ATTACHMENT 1

TECHNICAL SPECIFICATION CHANGES

CALLAWAY - UNIT 1

**SAFETY EVALUATION FOR THE
CALLAWAY PLANT MSFIS MODIFICATION
AND TECHNICAL SPECIFICATION AMENDMENT**

FIGURE 1
MSIV and FIV Valves
Current System

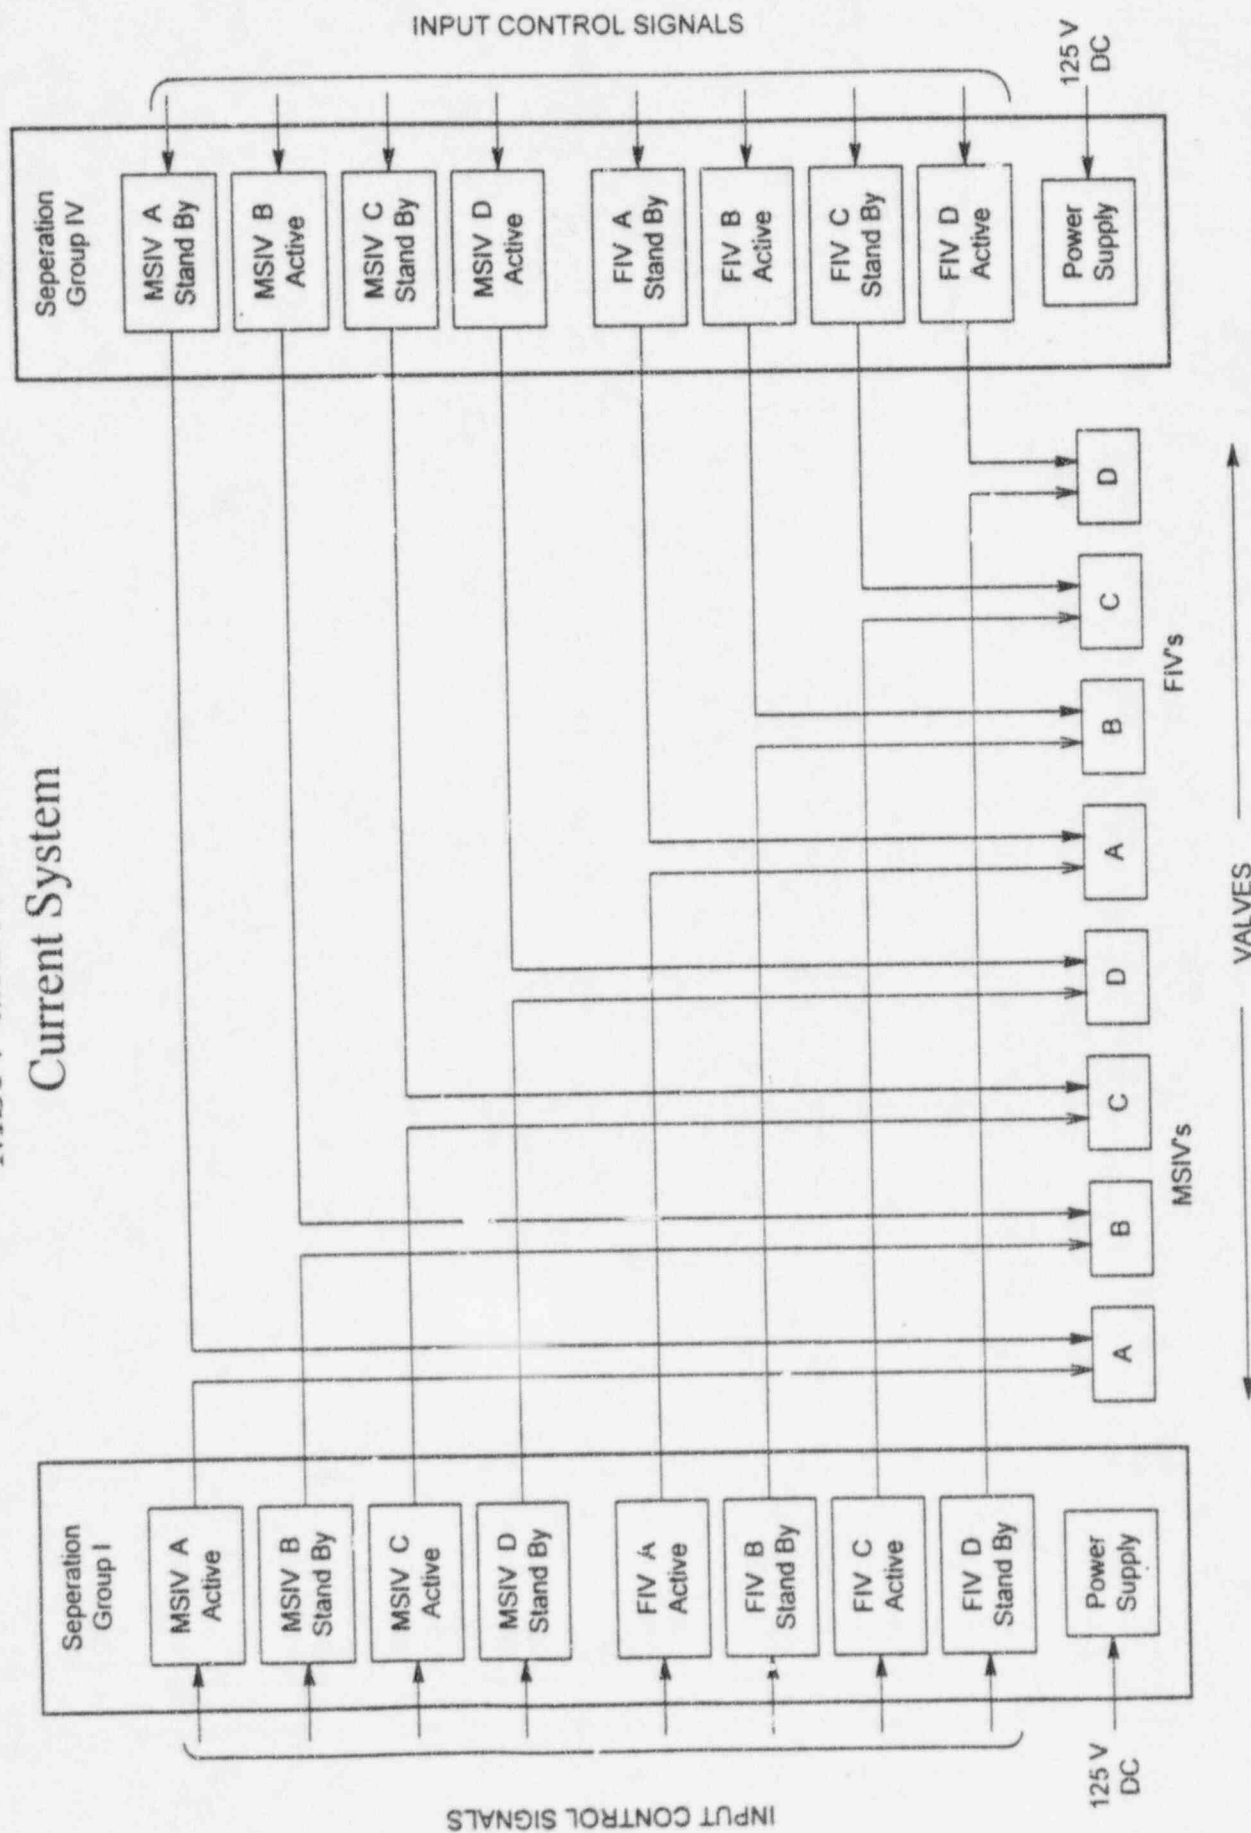
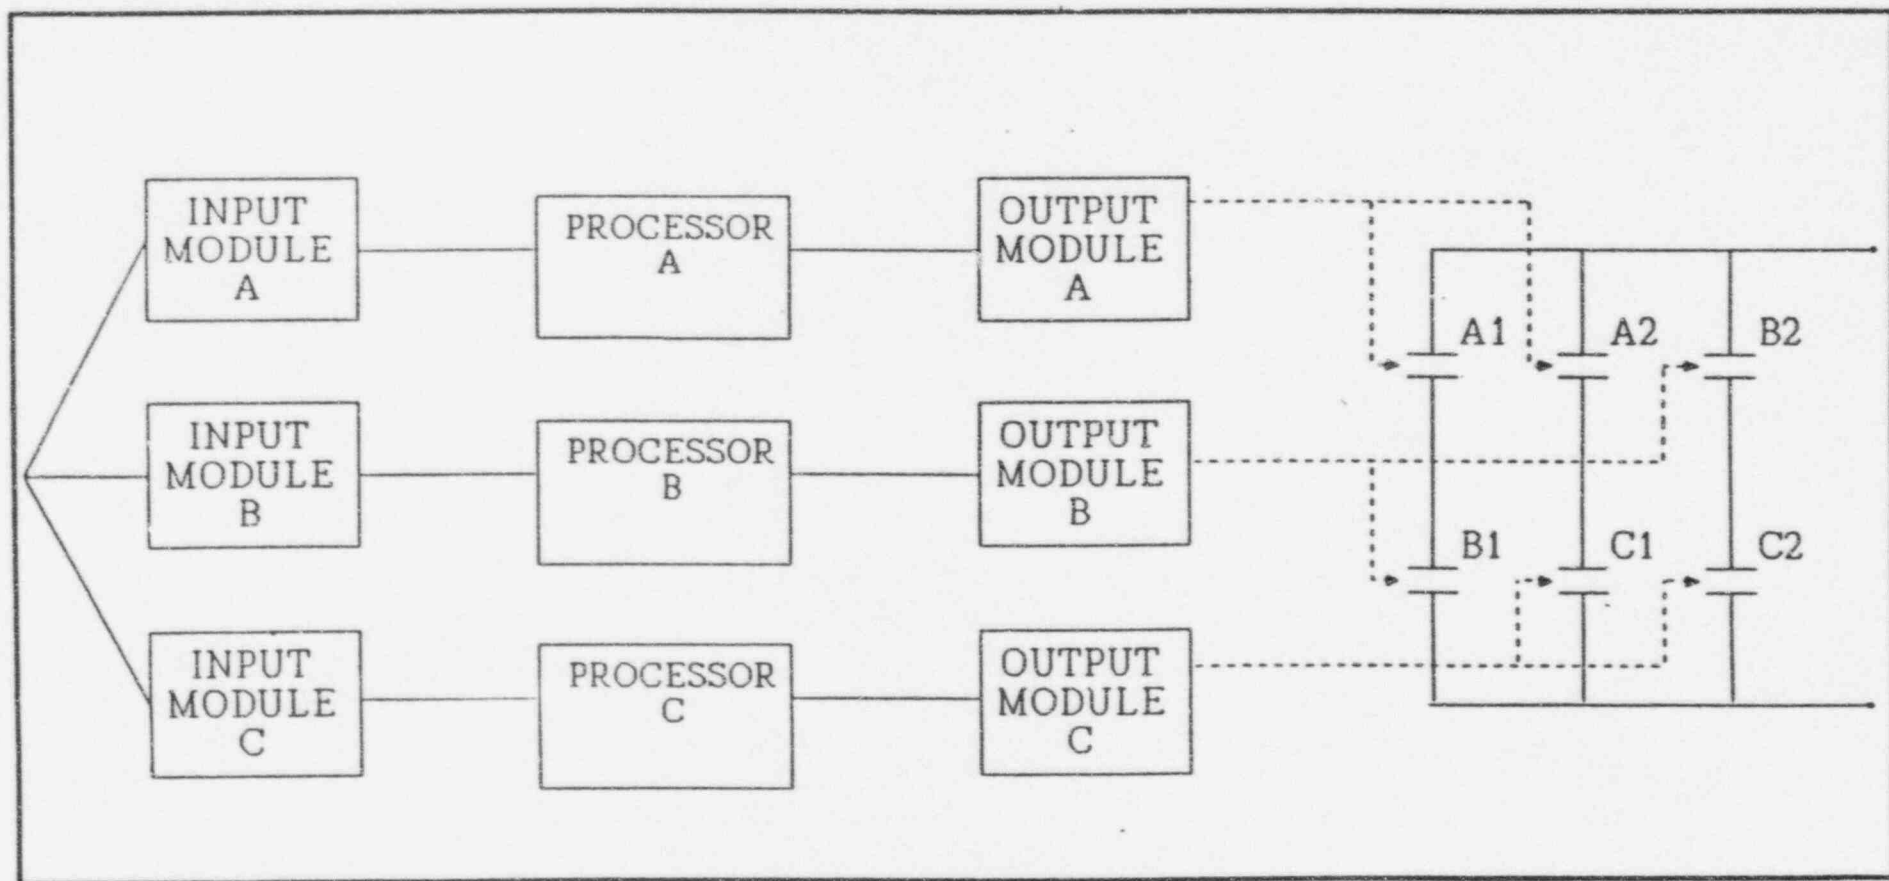
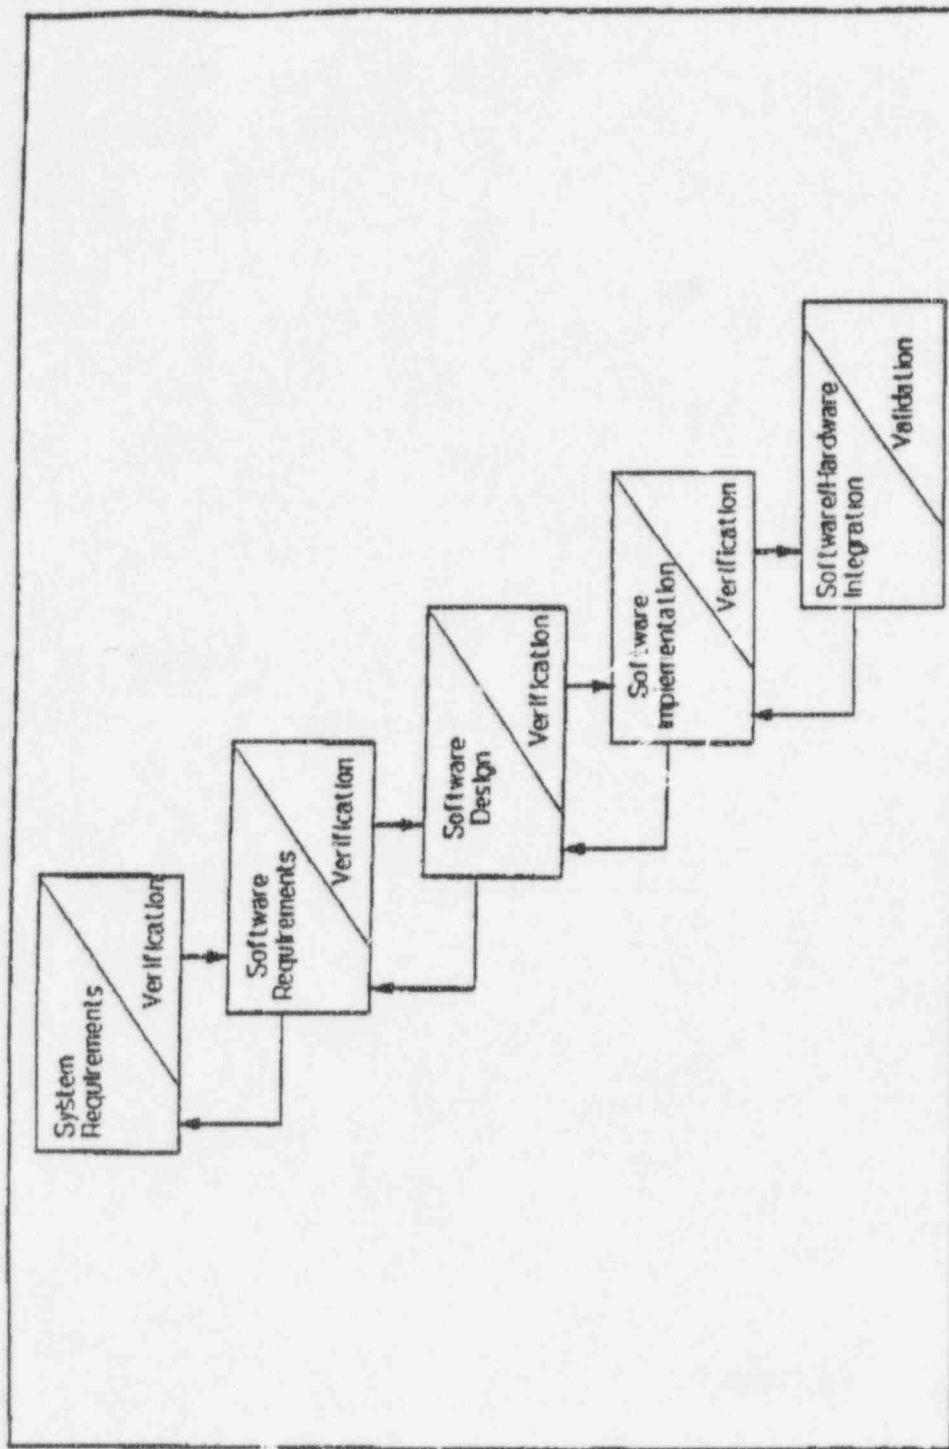
The system is composed of triple redundant logic consisting of three logic channels in two different trains or separation groups. The triple redundant logic will provide the MSFIS equipment with a 2 out of 3 voting scheme (see Figure 2). The output module contacts for each logic channel are normally open and close to trip. The 2 out of 3 voting scheme solves the problem of a 1 out of 2 nuisance actuation. To trigger an actuation, two logic channels (i.e., A-B, A-C, or B-C) per train trip and energize the actuation relays. Each train of MSFIS contains 3 PLCs, one for each logic channel. This logic design requires coincidence testing to ensure each set of combinations can produce an actuation. The 2 out of 3 logic design increases

plant reliability and availability. A single failure cannot trigger a false actuation, nor prevent a true actuation from occurring. If one logic channel fails, the affected train reverts to a 2 out of 2 logic. If a PLC channel failure occurs, a Channel Failure light will energize on the MSFIS test panel and the MCB annunciation of the Channel Failure will occur. This is discussed further in Section 3 of this evaluation. UE performed a Probability Risk Assessment that evaluated this logic scheme. This assessment showed that decreased risk of spurious actuation results in decreased risk of transient induced trips plant trips.
